ADDENDUM #1

PROJECT MANUAL FOR: CP221951 UMPB Ground Floor Renovation

CP221951 UPMB Addendum # 1

PROJECT: UPMB Ground Floor Renovations
PROJECT NO: MUHC – CP221951, R&B - 1202.0011414.000
DATE: September 16, 2022
BY: Tori Gillespie, Chris Philipp
RE: Addendum #1
DWG REF: See below
SPEC REF: See below
CC: Central File

A100

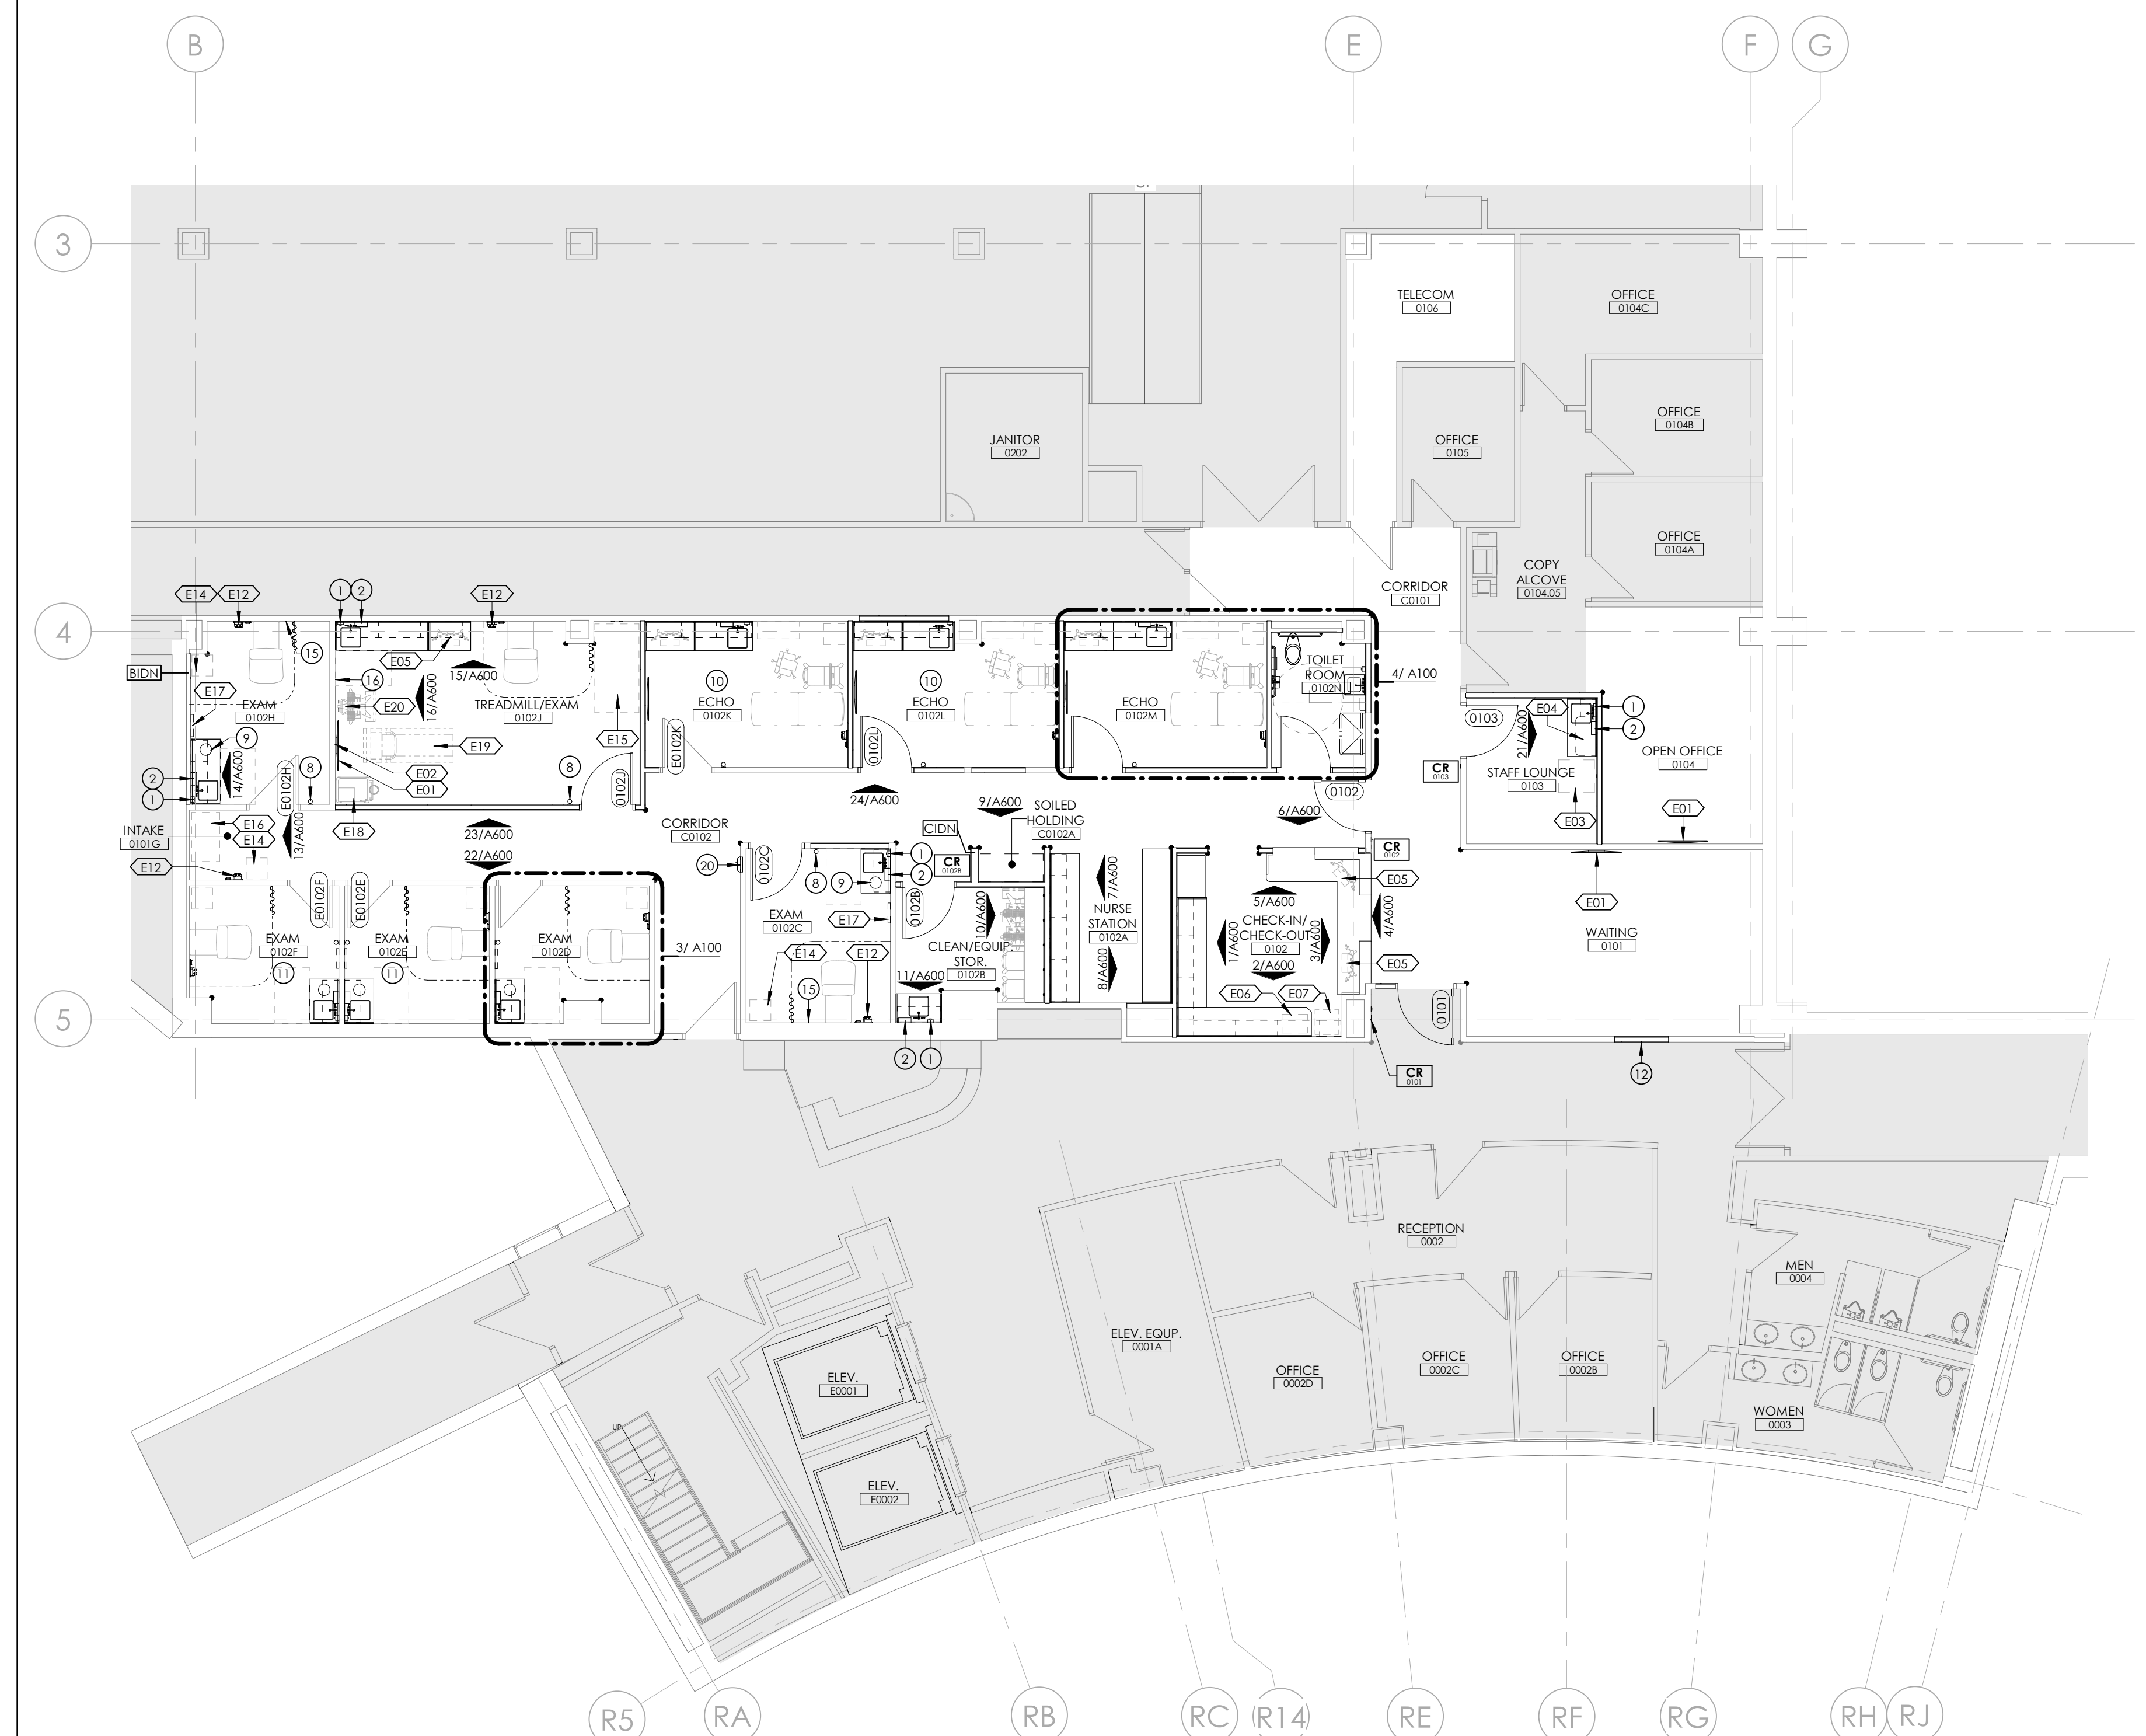
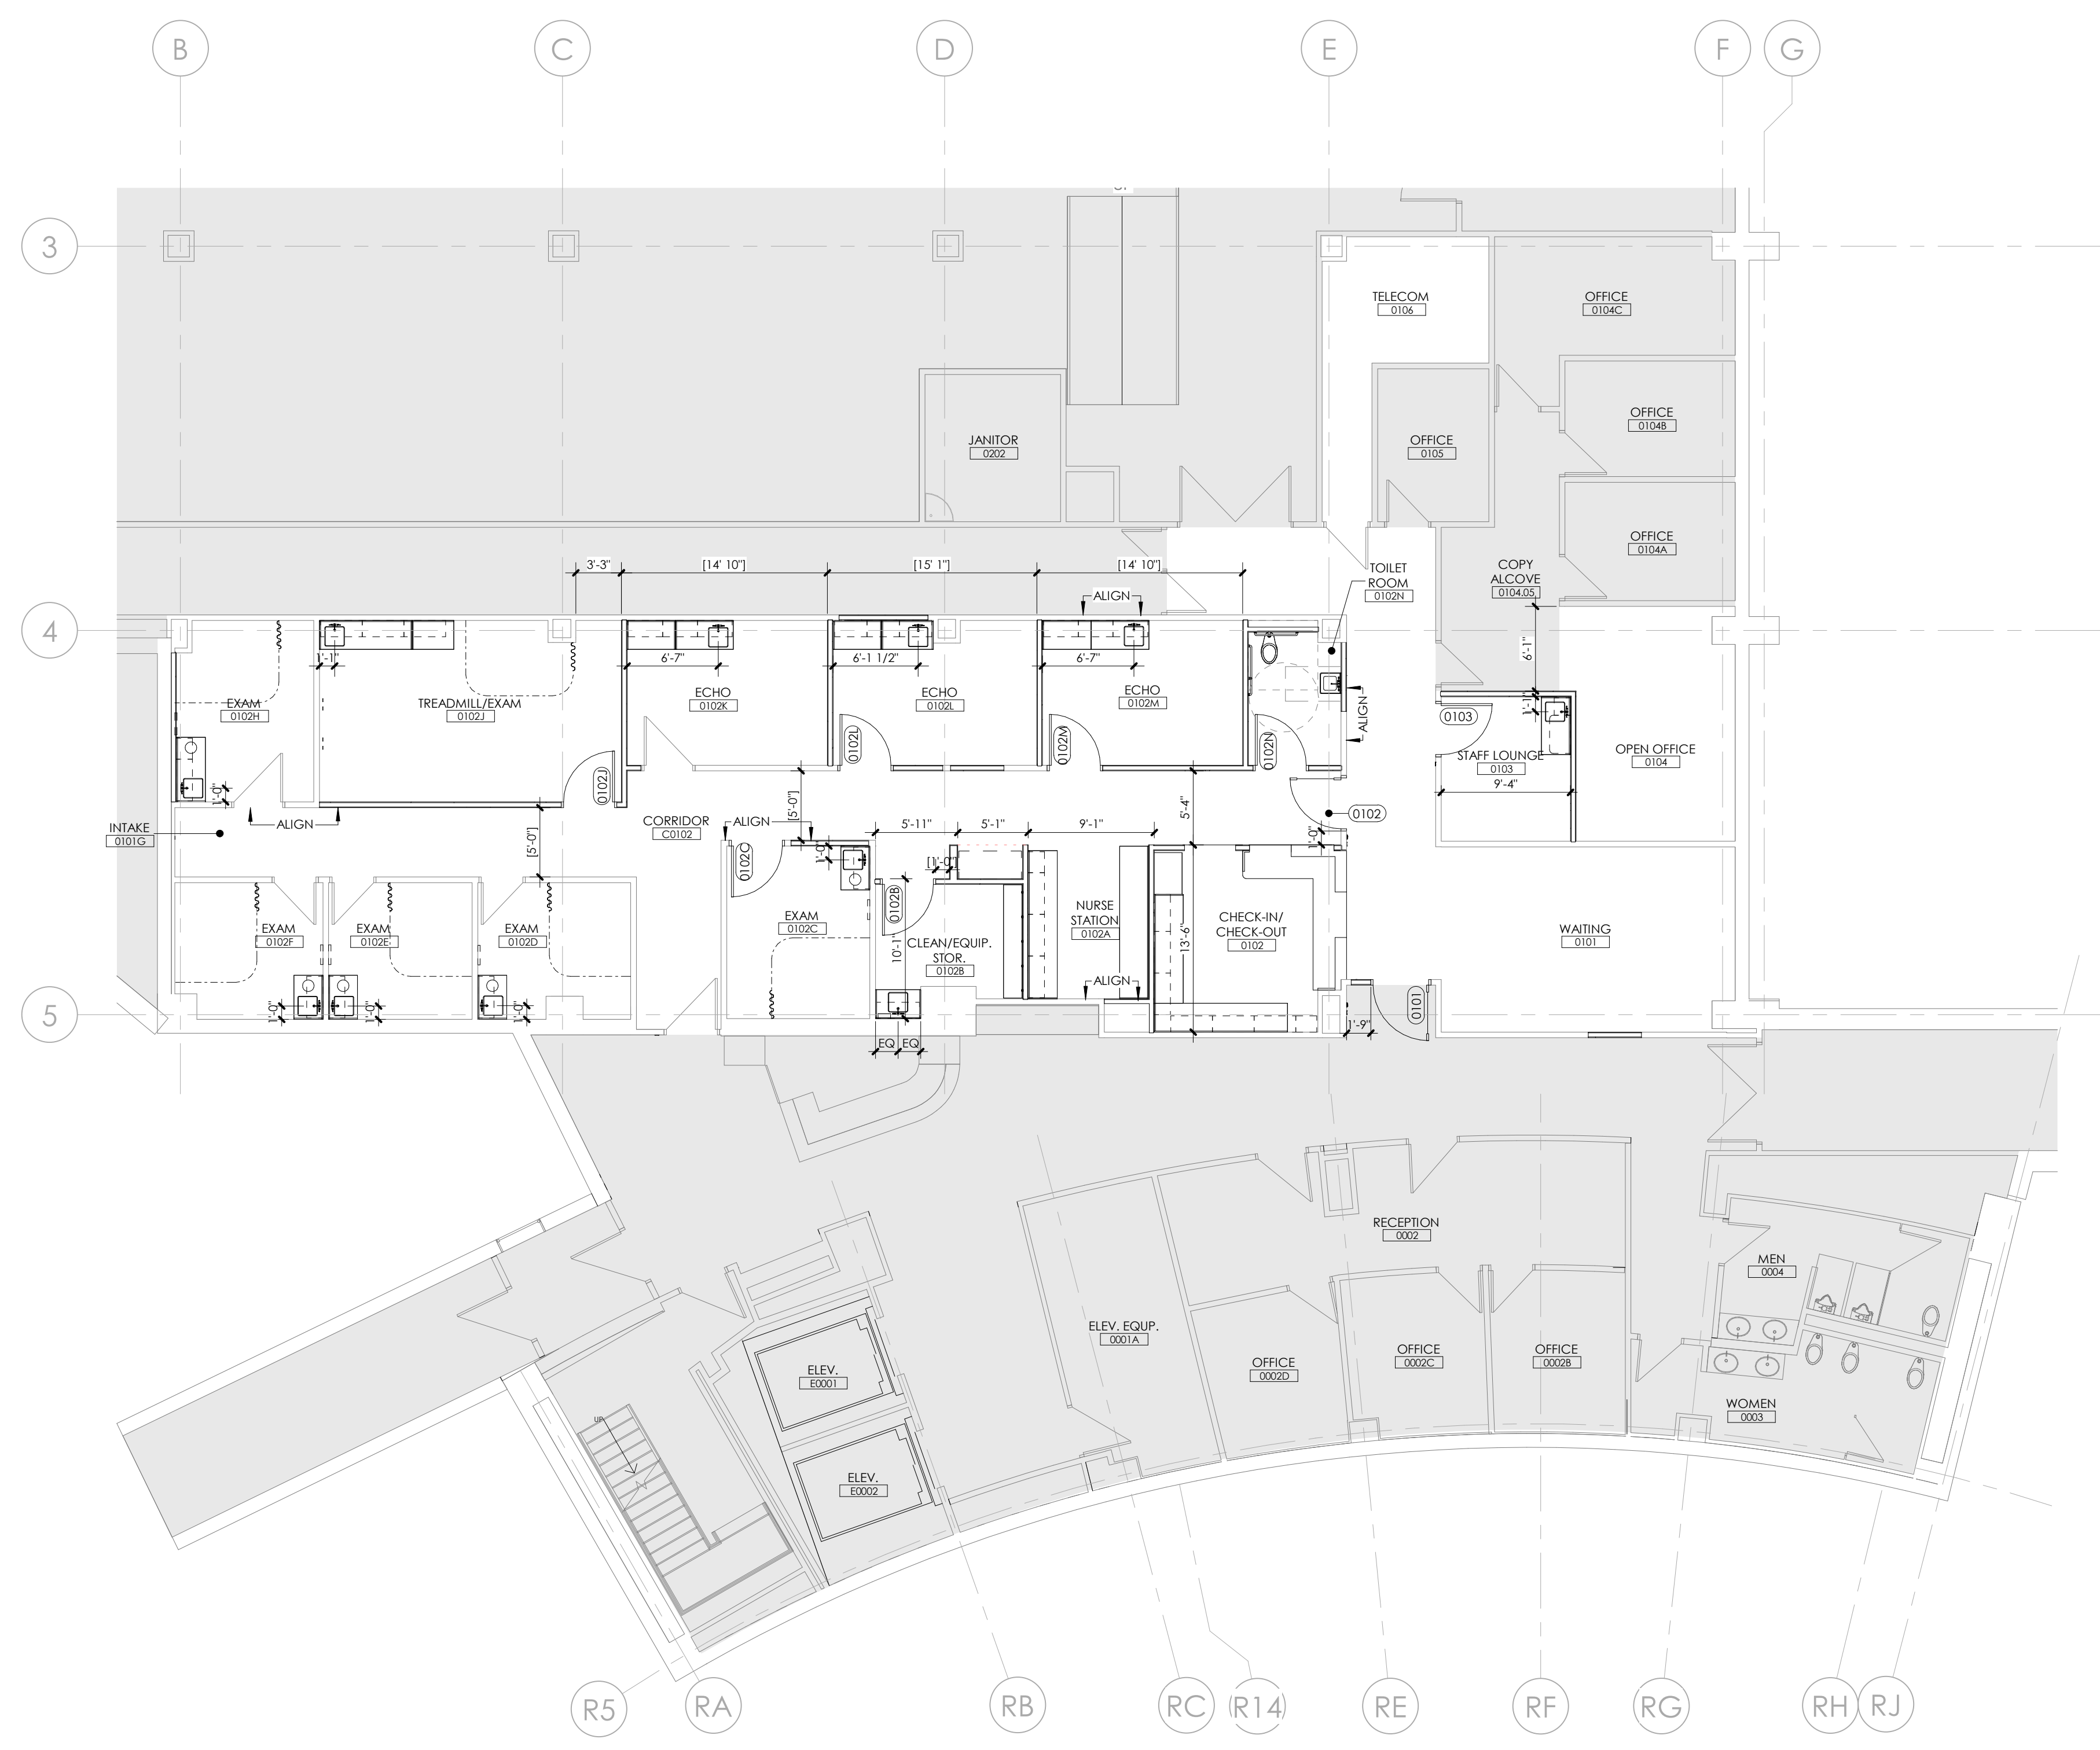
1. G100 – Added building risk category to Code Information per GBA comment. Grey hatch label updated to "No work, U.N.O."
2. G101 – Grey hatch added to Floor Plan Legend.
3. A100 – Grey hatch added to Floor Plan Legend.
4. A101 – Grey hatch added to Floor Plan Legend.
5. A200 – Grey hatch added to Reflected Ceiling Plan Legend and Finish Legend.
